Summary Design Modifications April 2018

COLORADO RIVER, CO

Need and Purpose Statement

2014 to 2018

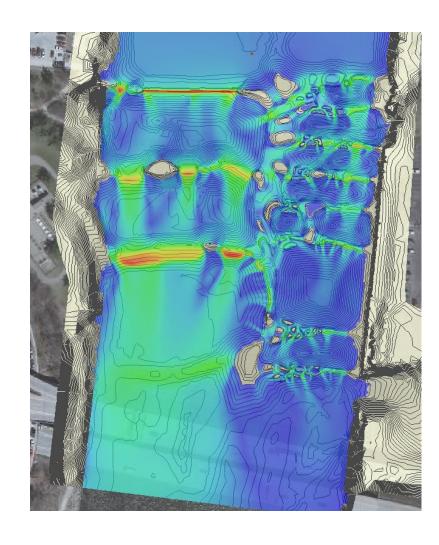
- Some wave features on the west side of the river were re-graded to be gradual riffles or runs
 - Specifically the features in front of the Public Museum and between Gillett and Pearl Street
 - Wave features have been reduced from 15 in 2012 to 8 in the current design
- The eight wave features that remain in the design, including the three large wave features near the dam, were diversified and reduced in width.
 - The additional area created by this reduction has been designed to be either a riffle, run, or boulder garden feature
- Diversity of flow direction was also enhanced to further naturalize the function and aesthetic of the reach

2014 to 2018 6TH Street Dam to I-196

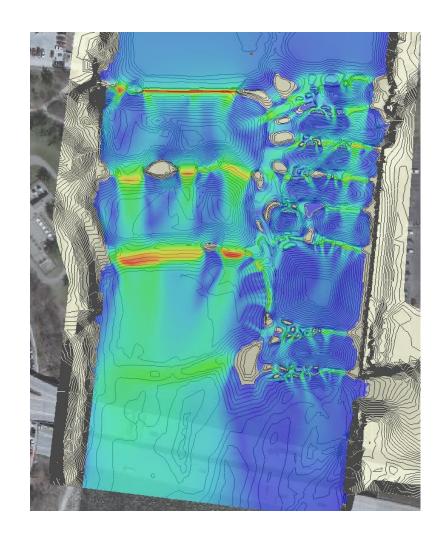
- Each of the passage features on the east side of the channel have been detail graded to contain a boat/tube route near the bank and a highly variable fish passage route adjacent to and throughout the bar in the channel center.
- The drops of the boat passage section have been diversified and more gradually graded than earlier iterations of design
- Maximum headloss over boat passage drops remains 9"

2014 to 2018 6^{TH} Street Dam to I-196

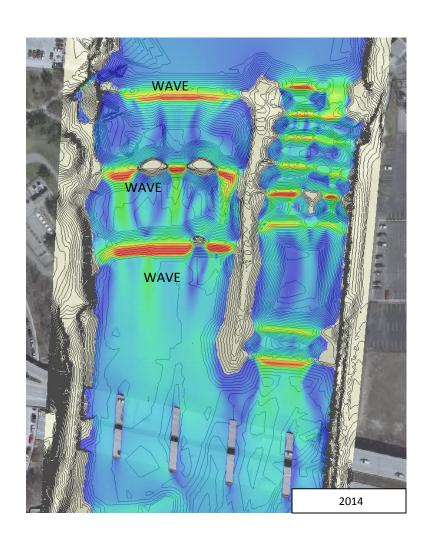
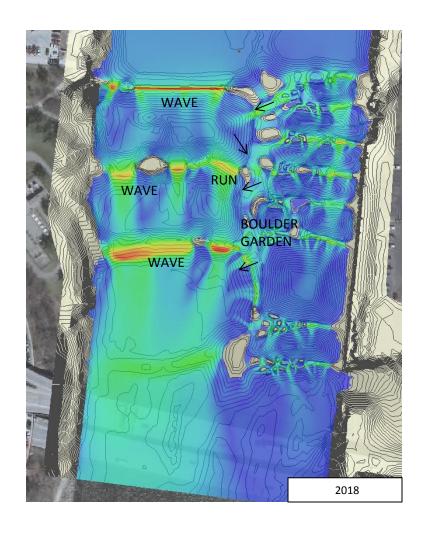
- A higher level of grading detail has been added to the center of the channel to better evaluate and accommodate fish passage and improved habitat.
 - Less average invert elevations are shown on plans and more specific locations of changes in elevation across a given invert are detailed
 - Specific input driving these updates were in regards to providing areas of relatively deep flow with low velocities for fish passage
- Gently sloped (2.5%) cross-flow between the two sides of the channel has been added through detailed grading
 - This was in an effort to maximize fish passage functionality and the natural aesthetic of the reach
